VD Mechanism
for D-550/720/850/900
SDT-9600/9610/7785

SERVICE MANUAL

No. 1081

July. 1978

Fig. 1 Adjustment of Pause Lock Plate

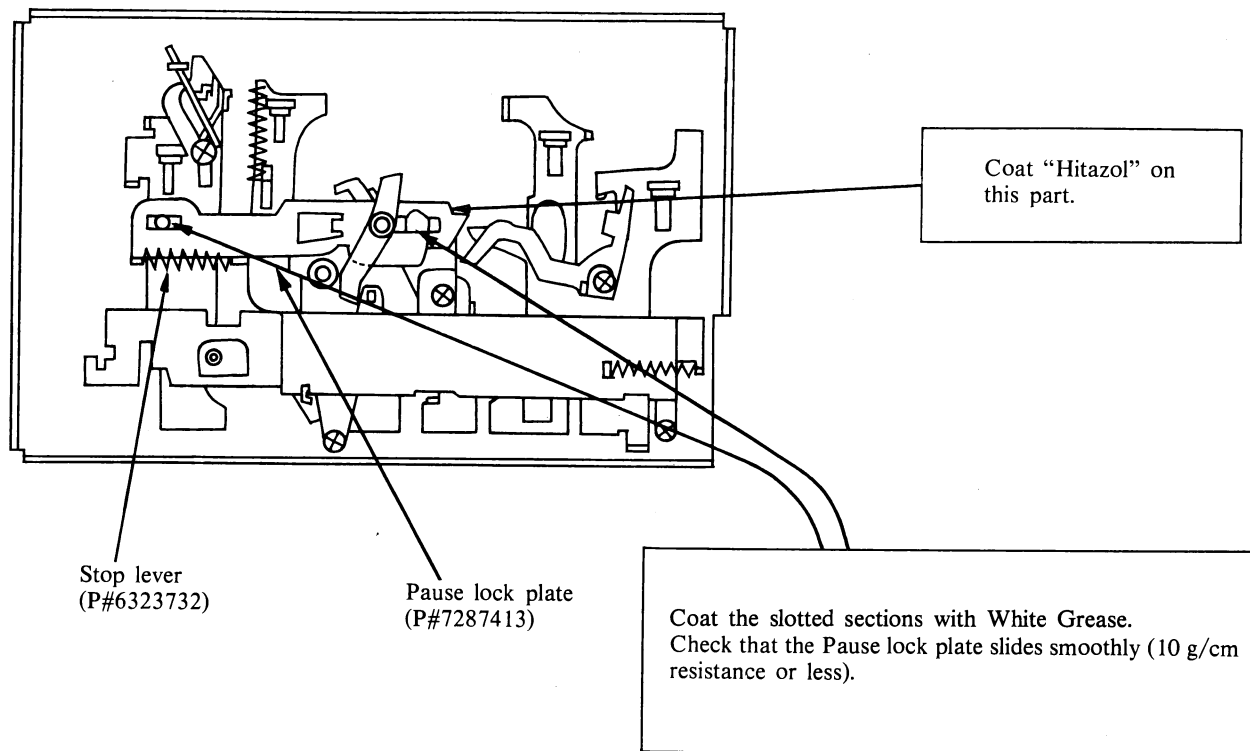
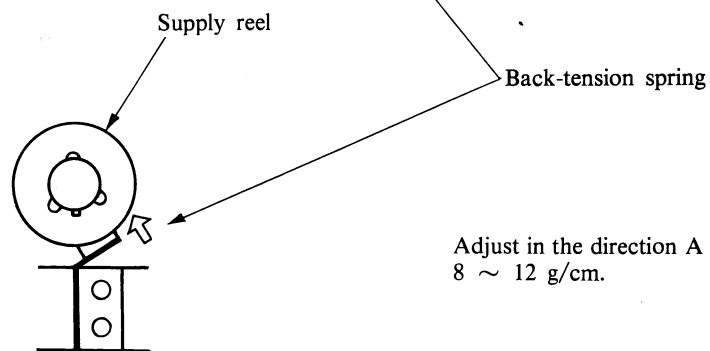
5.	Resonant sound produced when head plate operates.	• Resonance of PLAY slider spring.	• Coat 'Froil' onto external circumference of SPR.
6.	Head plate does not lock and repeats vertical movement.	• Sliding movement of P lock plate faulty.	• Correct deformation of P lock plate and lubricate with oil. (See Fig. 1)

Fig. 3 Adjustment of Brake Plate
(Related check item: C-4-1)

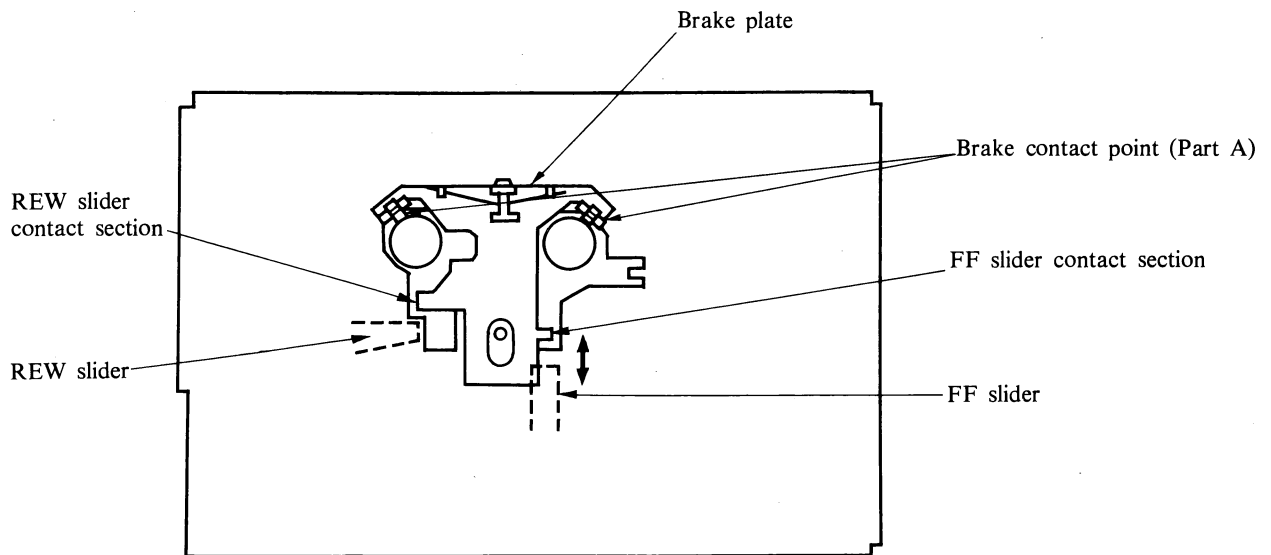
4.	Rotation speed changes during FF/REW operation.	1) Brake plate deformed and touches reel 2) Mounting of cassette faulty, causing slippage between clutch and hub.	1) Correct brake plate. (See Fig. 3) 2) Same as in B-5-1. (See Fig. 5.)

Check whether or not the parts of the brake, which are compressed and bent up by the FF slider, and REW slider are deformed. If deformed, remove them and correct. When the FF or REW button is depressed, there should be a gap of more than 0.5 mm at part A. Therefore check, that with a gap at part A and with the FF or REW button depressed, actuation of the STOP mode brings part A into positive contact.

Fig. 5 Cassette Tray Adjustment

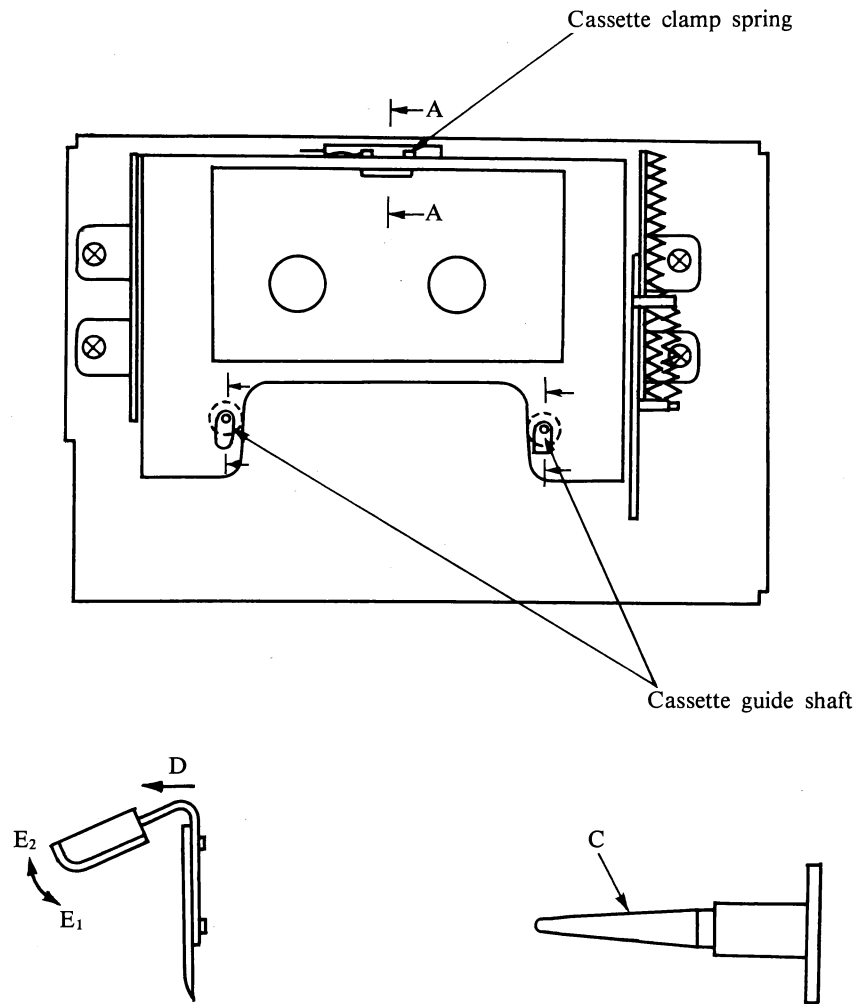
3.	Cassette cannot be inserted completely and is lifted up.	1) Cassette clamp spring positioned incorrectly. (Right side displaced upward.) 2) Cassette guide shaft surface finish	1) Same as in B-5-1. (See Fig. 5.) 2) Coat a little silicone grease onto upper surface of guide shaft. See Fig. 5.)

When the top of the cassette cannot be inserted completely into the tray, bend the spring while lifting the cassette clamp spring in direction D.

When the cassette is caught by the cassette clamp spring and is retained during the EJECT operation with the cassette still inserted, this is because the spring is bent too much in direction E₁. Bend it slightly in direction E₂.

When the bottom of the cassette catches on the cassette guide shaft, grease part C, which the cassette touches, very lightly with gauze using silicone grease and wipe it off leaving only a trace of grease.

SUBJECT Modification of the Head Plate Spring on the VD Mechanism

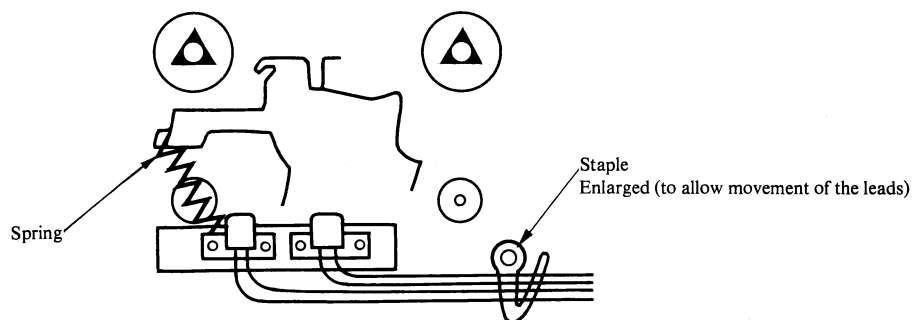
Due to hardening of the head lead wires at low temperatures some heads do not advance to the normal position on pressing the playback button, therefore the head plate spring has been changed. In addition, at the same time as spring replacement, the wiring clamp shown in the figure below has been enlarged to allow freedom of movement of the leads.

No.	Parts No.	Description	FOR Y Japan	*	Parts No.	Description	FOR Y Japan
	6302221	Spring		$\overrightarrow{A B}$	6324436	Spring for D-550AU/RW/ W/BS/FS/U D-720C/RW SDT-7785E/F/S	
				$\overrightarrow{A B}$	6300031	Spring for D-720U/AU/ W/FS SDT-9600H/C	
				$\overrightarrow{A B}$			
				$\overrightarrow{A B}$

SUBJECT VD Mechanism Brake Adjustment

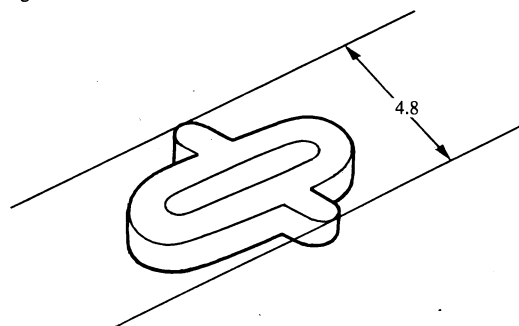
During prolonged used of the pause function, low brake torque causes tape slackness to occur; therefore the brake rubber has been modified.

No.	Parts No.	Description	FOR ¥ Japan	*	Parts No.	Description	FOR ¥ Japan
	6586072	Brake rubber		AB	6586071	Brake rubber for D-550AU/ RW/W/BS/FS/U D-850U/C/BS/FS/W/AU SDT-7785E/F/S	
				AB	6586002	Brake rubber for D-720U/AU/W/ FS/C/RW SDT-9600H/C	
				AB			
				AB

SUBJECT Discharge Noise Created by the VD Mechanism — Countermeasures

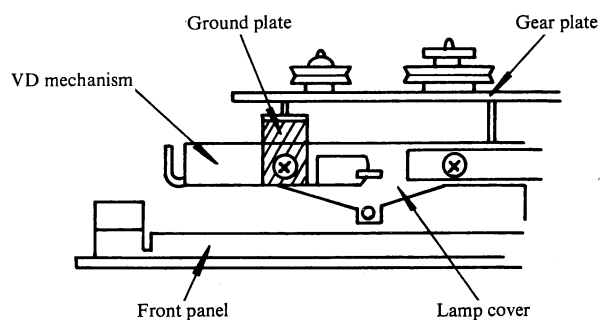
Electrical discharge noise which is caused by the charge generated by friction produced during rotation of the take-up pulley and fly-wheel belt pulley, etc. is cured by installation of a ground plate, as detailed below.

To mount the ground plate: Remove the screw at the left side of the lamp cover, and insert the ground plate between the VD mechanism and the lamp cover. Tighten the new assembly.

SUBJECT Modification of the AS Control Spring for the VD Mechanism

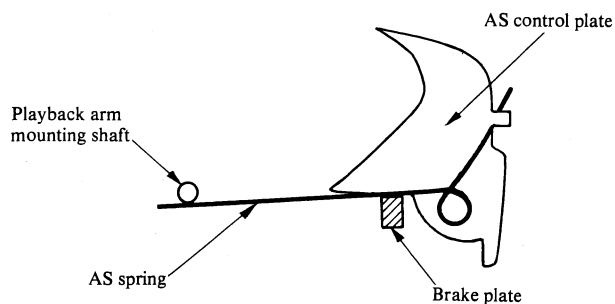
To improve the efficiency of installation and to prevent the spring shipping out of its location.

No.	Parts No.	Description	FOR Y Japan	*	Parts No.	Description	FOR Y Japan
1	7295951	AS control plate		$\overline{A} B$	6307924	AS control spring for D-550AU/ RW/W/BS/FS/U SDT-7785	
2	6308301	AS spring		$\overline{A} B$	6307921	AS control spring for D720U/ AU/W/FS/C/RW SDT-9600H/C	
				$\overline{A} B$			
				$\overline{A} B$

SUBJECT Improvement of wow-flutter.

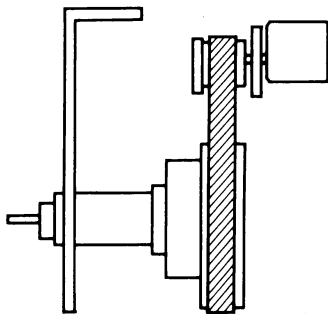
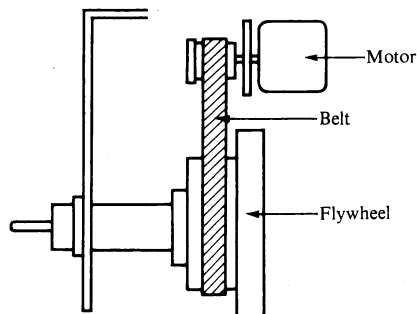
No.	Parts No.	Description	FOR ¥ Japan	*	Parts No.	Description	FOR ¥ Japan
1	5572752	Motor with motor pulley		$\overline{A B}$	5572552	Motor for D-720	
2	6357082	Motor belt		$\overline{A B}$	6357161	Motor belt for D-720	
				$\overline{A B}$	5572553	Motor for D-550BS/FS W	
				$\overline{A B}$	6420221	MOTOR PULLEY for D-550BS/FS/W

SUBJECT Improvement of Auto Stop Malfunctioning

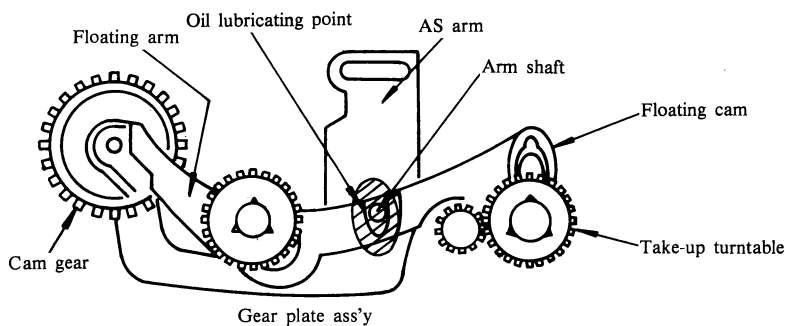
Tape transportation is stopped by operation of Auto stop mechanism in playback mode. To improve it the following modification has been made.

1. Remove gear plate ass'y. Lubricate pan motor oil to contact surface of floating arm and arm shaft and AS arm.
2. Make sure that AS arm moves smoothly.

SUBJECT Improvement of Mechanical Sound

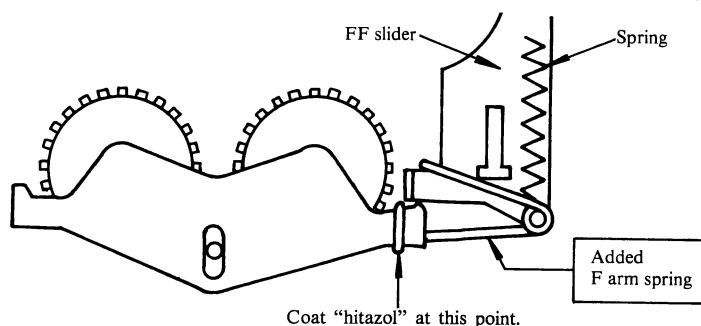
Mechanical sound is produced from F gear of gear plate. To improve it, the following modification has been made.

No.	Parts No.	Description	FOR ¥ Japan	*	Parts No.	Description	FOR ¥ Japan
	6308941	F arm spring		$\overline{A B}$			
				$\overline{A B}$			
				$\overline{A B}$			
				$\overline{A B}$

SUBJECT Improvement of Pause Mechanism

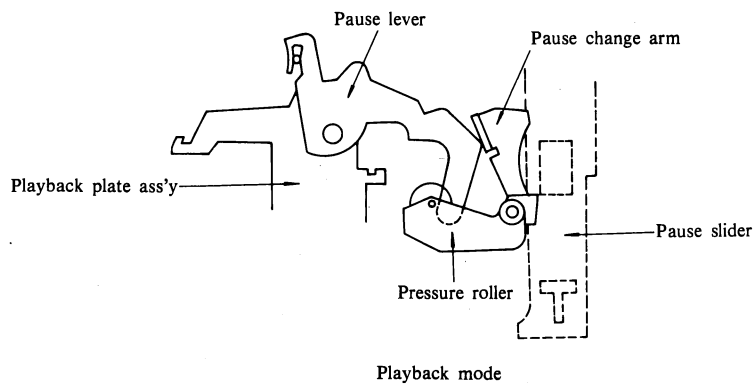
In former pause mechanism, when pause button was depressed to stop the tape transportation temporarily during playing back or recording, heads and pressure roller return to original position.

This caused slow tape speed at beginning when pause mode was released.

To solve this problem, pause mechanism has been changed as described below.

1. Heads keep touching tape surface.
2. Pressure roller comes away from capstan.

SUBJECT Improvement of Hum

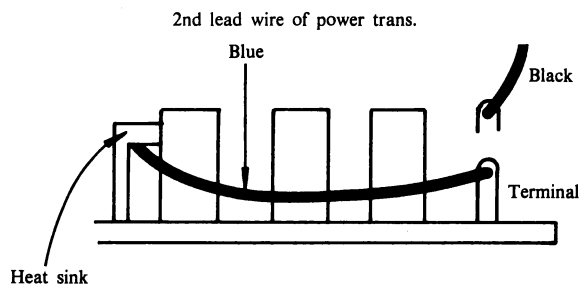
To decrease hum wiring of secondary wire (P.T) is changed.

Wire "Blue" is paralleled with "Black" on original model.

After changing, "Black" is left as in the original, and "Blue" is changed as below.

SUBJECT Improvement of Mechanical Sound

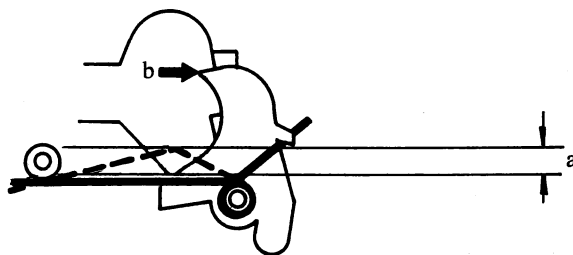
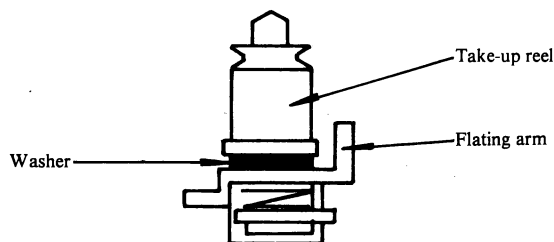
Mechanical sound occurs in STOP mode. To improve it, the following modification has been made.

1. Bend AS spring as shown by dotted line.

Dimension of "a" is 1—2 mm from AS control spring to point where AS control plate and chassis intersect.

2. Check tension at point "b" with tension gauge that AS control plate starts to rotate with 4—6 gram tension. If measured tension is not within 4—6 gram, readjust the bend of AS spring.
3. After assembling, turn on the power.
